**x6000-05-S**

# **S E R V I C E N O T E**

## Medalist x6000 Systems

### POSSIBLE X-ray Emission HAZARD

Picture of replacement part N7280-88786:

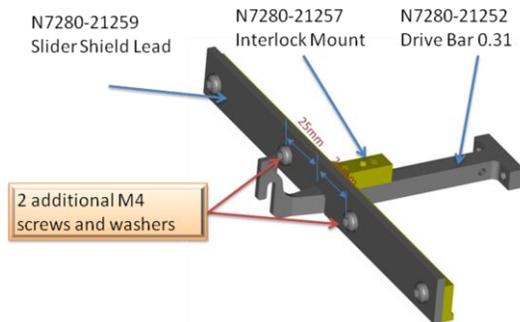
The original design of the lead bar on the inner barrier did not originally include enough screws in the design to hold the lead in place, such that it will fail after many 100,000s of cycles. As a result the x-ray emissions might be able to go above the Agilent specification once the lead bar fails. The concern for leakage is when the bar has cracked/failed by breaking in half and the left outer barrier is opened.

Using the replacement part N7280-88786 (inner barrier replacement kit, qty 1) will be required to update the inner barrier drive bar. Please return the used part for refurbishing.
